Objection submission COM/2019/81 - Is the Council aware of the DA's planned proximity to the Tamborine Oxenford Road, the Maudsland Road and the John Muntz bridge and how it is contra to City Plan 9.3.8

Historical and Proposed comparison of Western boundary

Attachment A3 - West side of quarry and John Muntz Bridge 1st July 2015

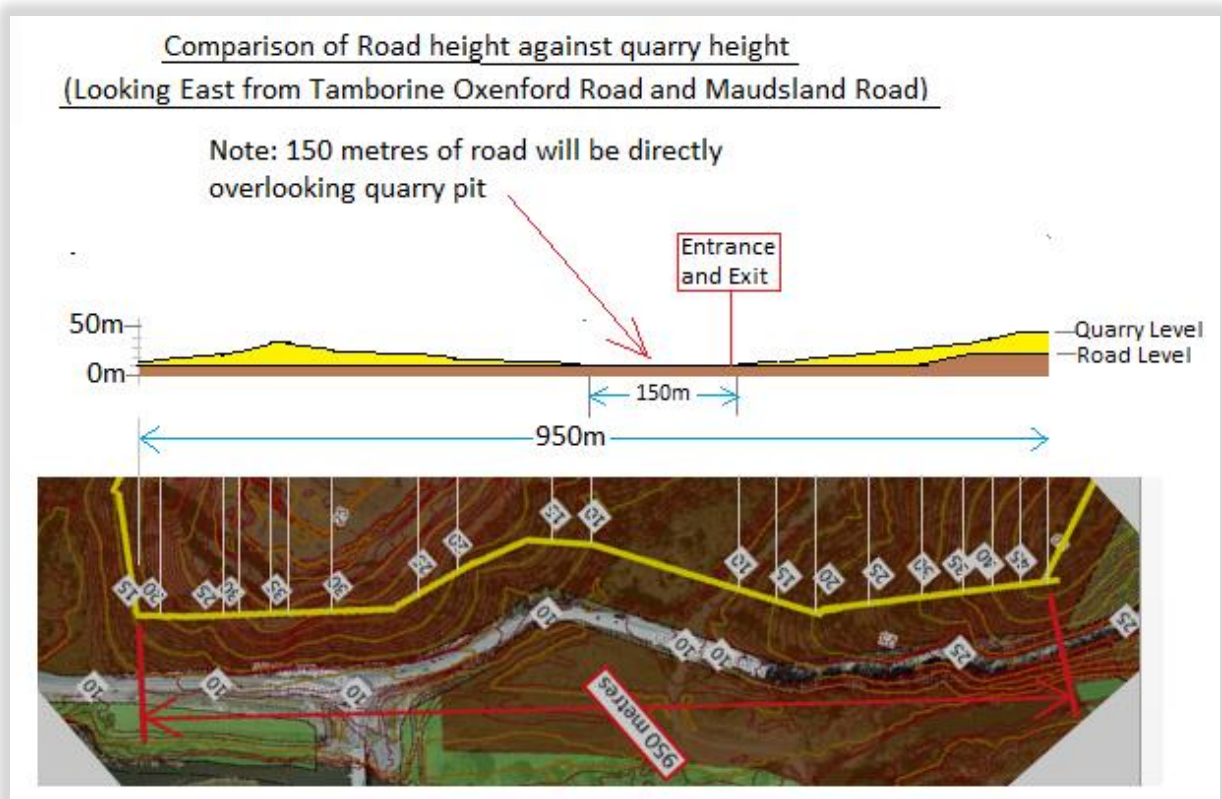
Attachment A1 show how the quarry was a few hundred meters from the road in 2004 (Attachment A1), whereas in 2008 it has progressed rapidly towards the western boundary (Attachment A2). By 2015 it is yet closer and far deeper (Attachment A3). In 2020 it is just 60 m from the boundary at its narrowest (Attachment A4).

Attachment C1 - Visibility of quarry pit from Maudsland Road

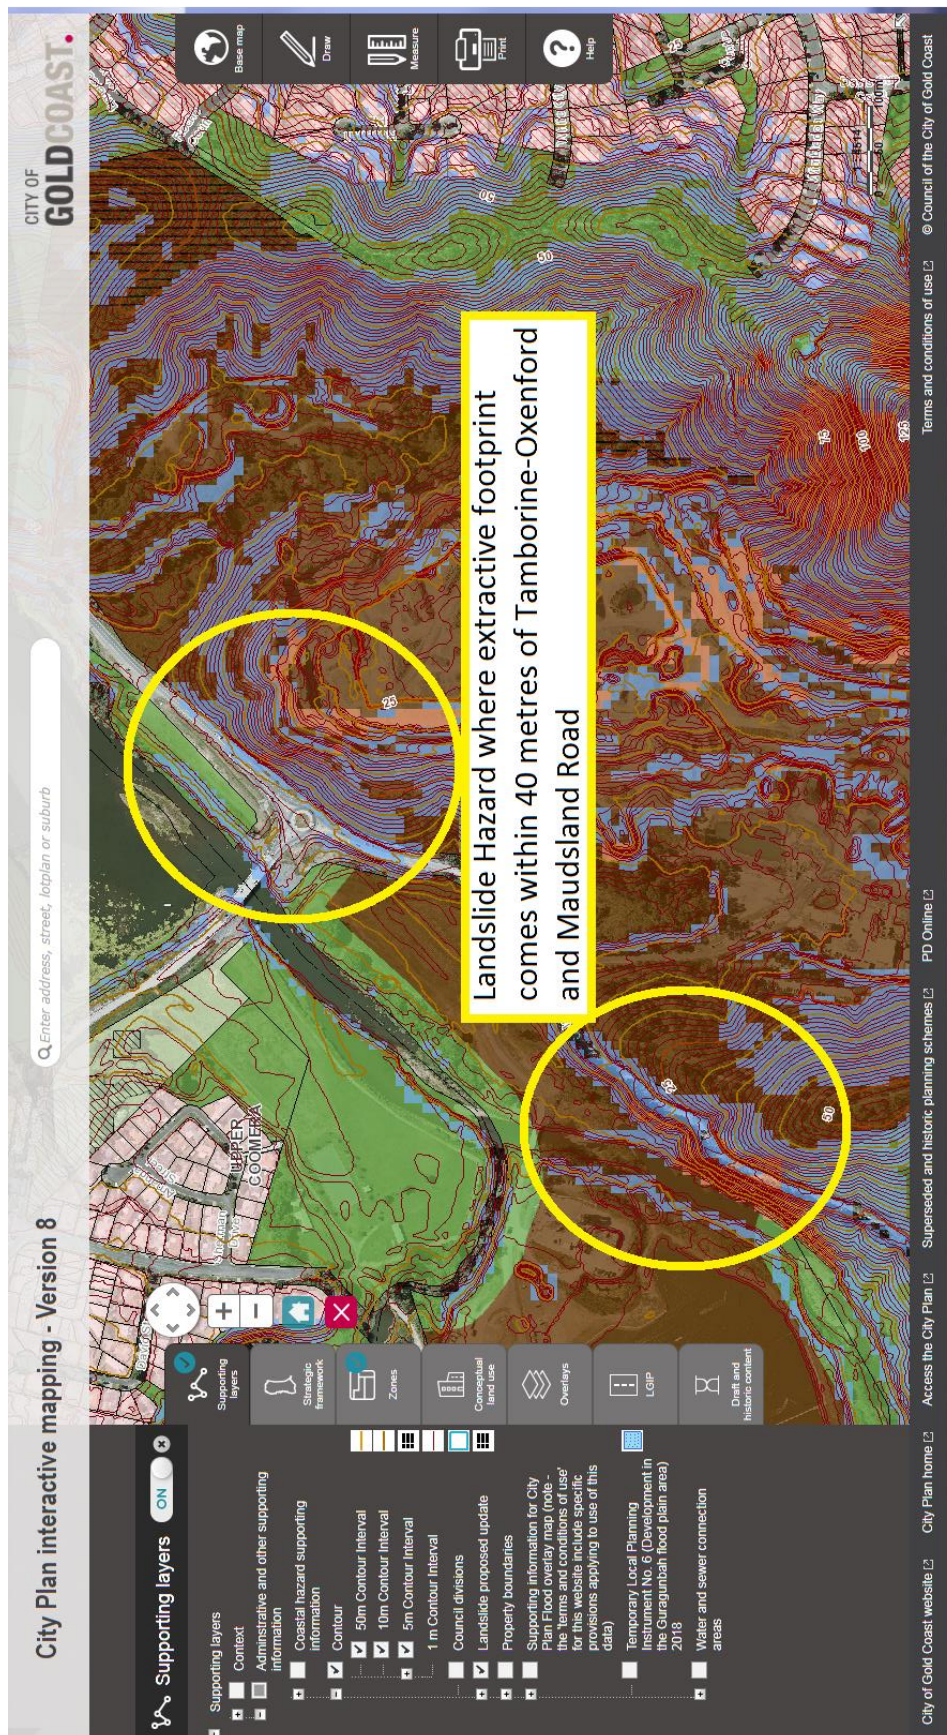
It should be noted further South, along the western flank, there will be no physical barrier by way of any hillside protection whatsoever for approximately 150m distance along the Maudsland Road (See Attachment C1).

**Figure 9.3.8-1**

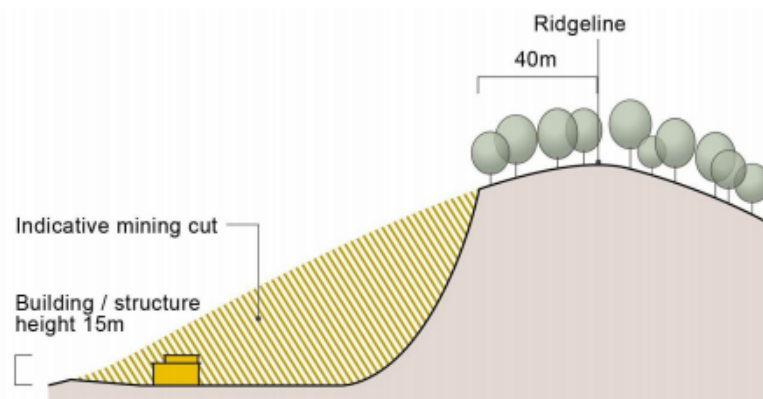
The successive and relentless removal of the ridge top throughout this northern section of the western flank is also contra to the clear requirements of City Plan ‘9.3.8 Extractive Industry development Code ‘Performance Outcome PO4’: *“Development protects the visual character and amenity of the area by ensuring ridgelines are retained as a natural feature and buffer”* and ‘Acceptable Outcome A04’: *“Development is located at least 40m away from any ridgeline, as measured horizontally from the ridge peak”* (Attachment E1). It will be highly visible, along with the trucks entering and departing throughout the area for the life of the proposed quarry given that the access road appears to be planned for the top of this ridge, on the limits of the 40m boundary (and even less in places) adjacent to Tamborine Oxenford Road (Attachment F1).

Attachment F1 - Extractive Footprint - Haulage route out of quarry

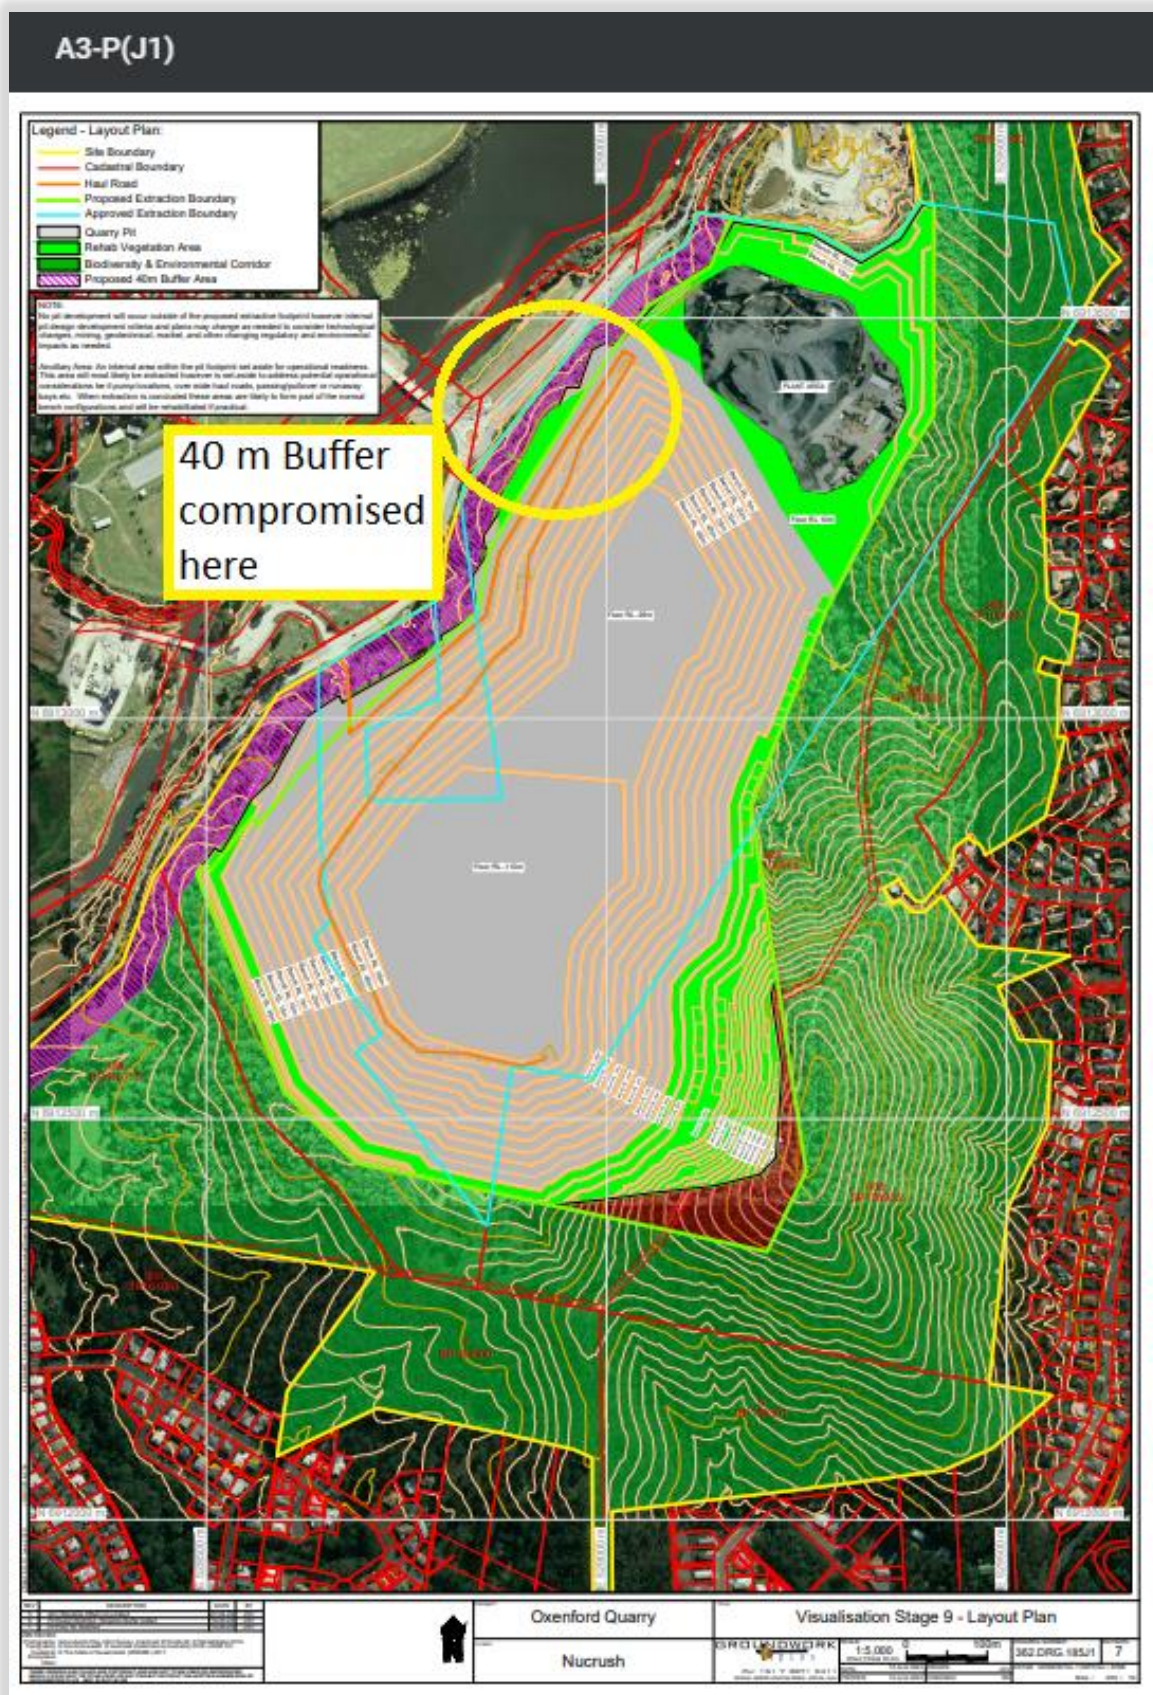
How can it possibly be permitted to blast and extract, with the proposed 15 metre bench drops, in a Landslide Hazard area with such steep banks and within 40 metres (less in places - Attachment F1) of a very busy, popular public road? (as shown in Attachment D1).

It should also be noted that the submitted ‘Visualisation Stage 9’ (Attachment F1) clearly shows that the 40 m boundary from the Tamborine - Oxenford Road will be compromised. This is not permitted under City Plan 9.3.8.3. Acceptable Outcome AO3.1: *“Extraction or processing activities are not conducted within 40 m of any boundary of the site”* (Attachment E1).
